Response to Last MAC Recommendations

V.Ptitsyn

C-AD, BNL

Proton Intensity Upgrade

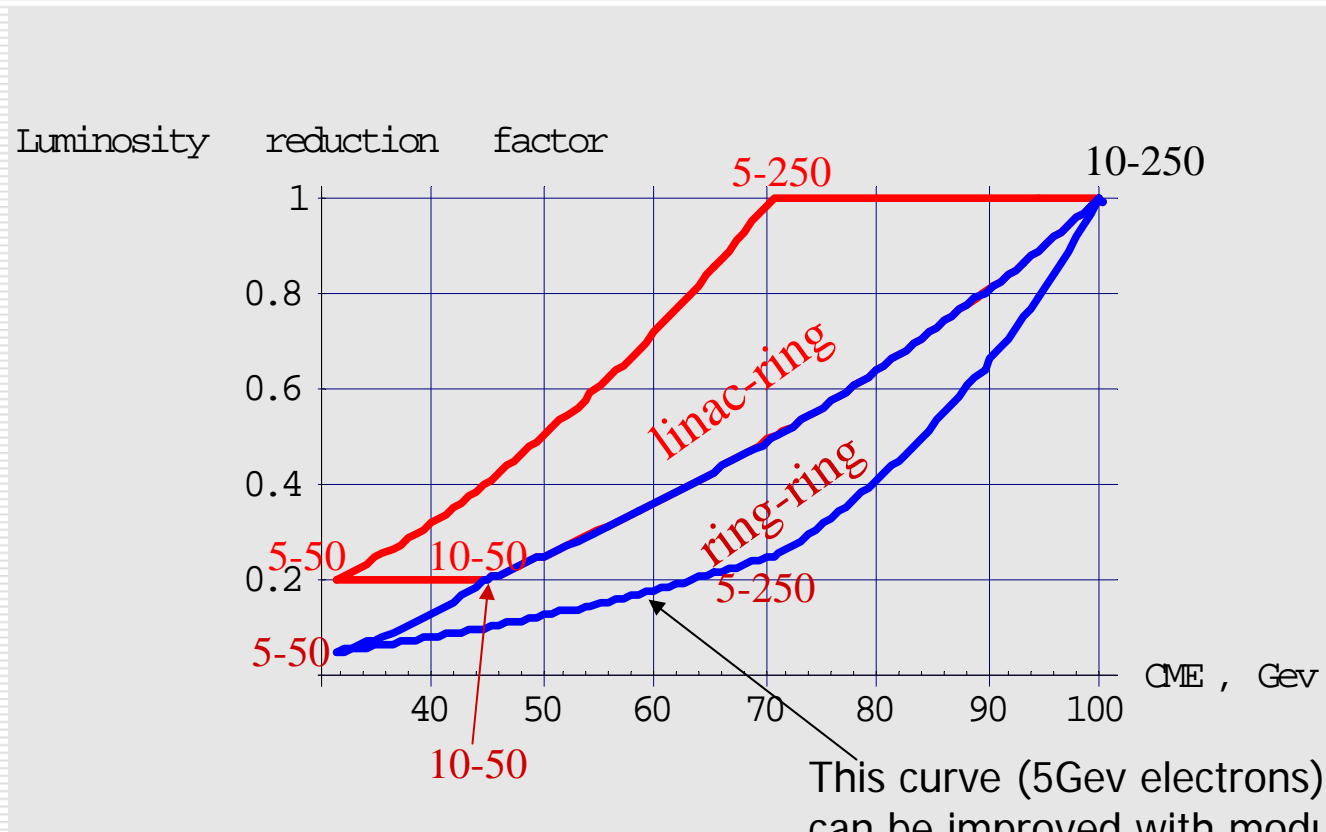
- **Recommendations:** The collider-accelerator department should put a large effort in overcoming the intensity related vacuum problems including **the continuation of the e-cloud studies, the NEG coating of warm sections and improved dynamic vacuum conditions in the cold sections.** All other potential intensity limitations in RHIC have to be studied carefully.

- **Response:**
 - Following year-to-year continuous upgrade of RHIC vacuum system, the total beam intensity of ion (proton) beam have been continuously increasing.
 - During beam studies at Run-5 the Blue total beam intensity more than $3e13$ protons was achieved at the injection energy which is comparable with the total beam intensity planned for eRHIC.
 - Further improvements of the vacuum conditions, including the vacuum in cold sections, expected in the coming run.

Beam-beam simulations (Yun Luo)

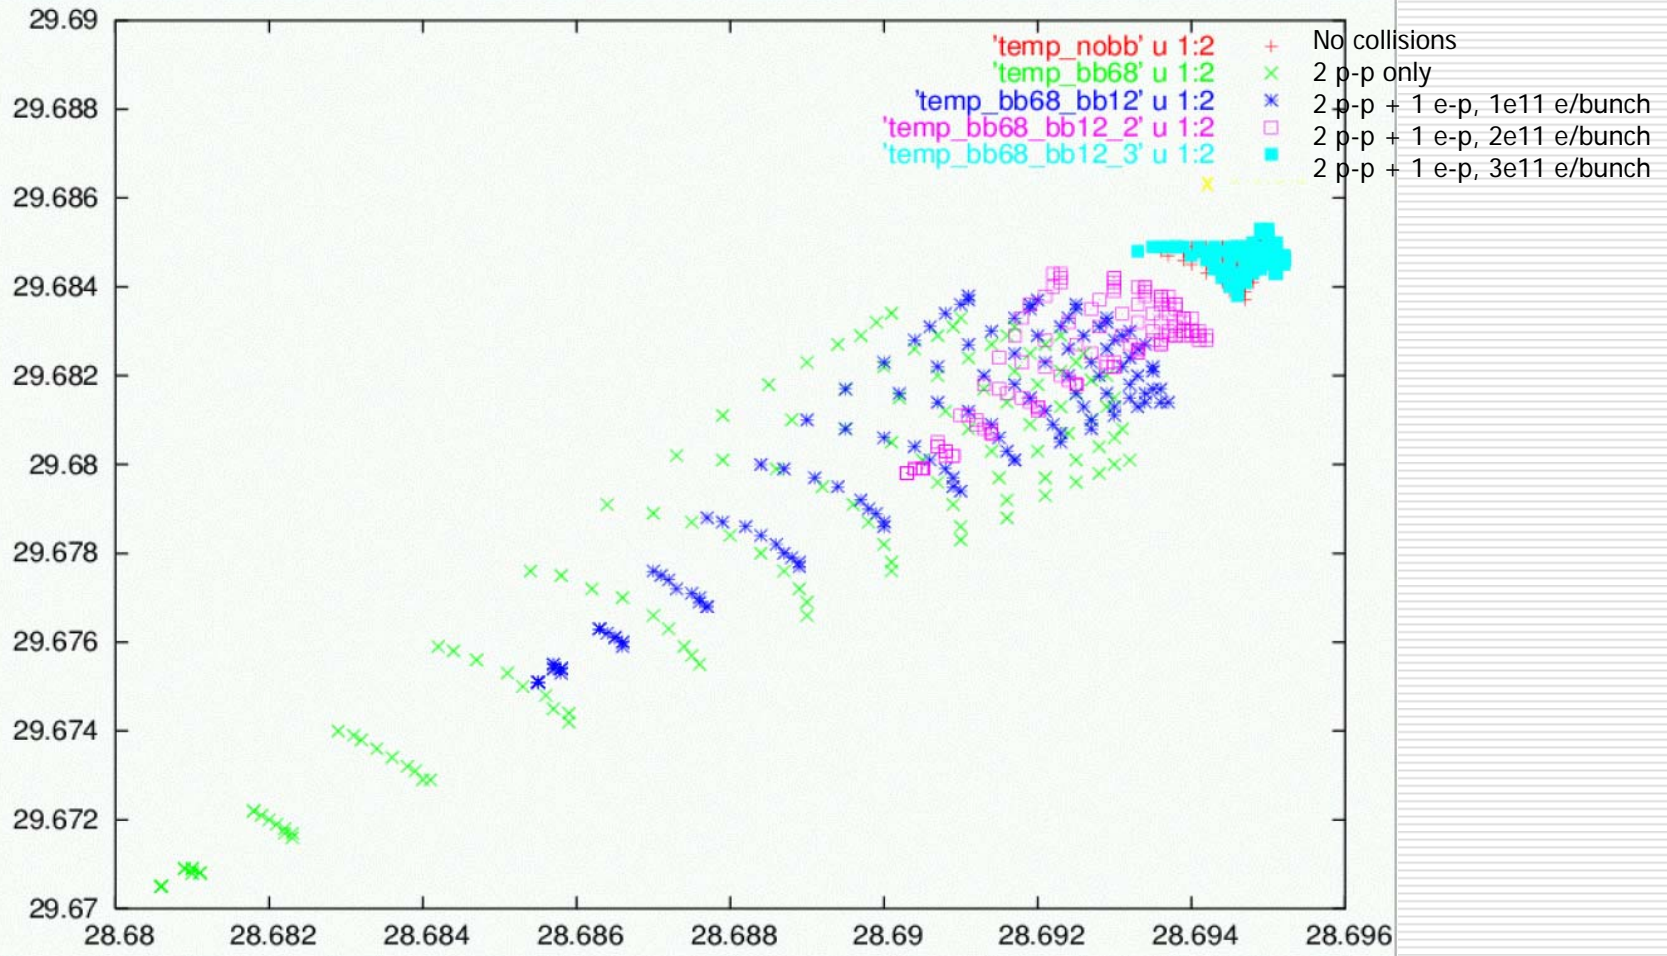
1. Continue the benchmarking of coherent beam-beam simulation codes with RHIC.
2. Perform electron beam-beam simulations avoiding coherent beam-beam resonances and synchro-betatron resonances for 360 bunches.

Beam-beam simulation done for parallel operation mode demonstrated tune footprint compensation from e-p and p-p collision. Proton beam-beam parameter higher than present design value is possible.

Further simulations are planned, including strong-strong beam-beam simulations.
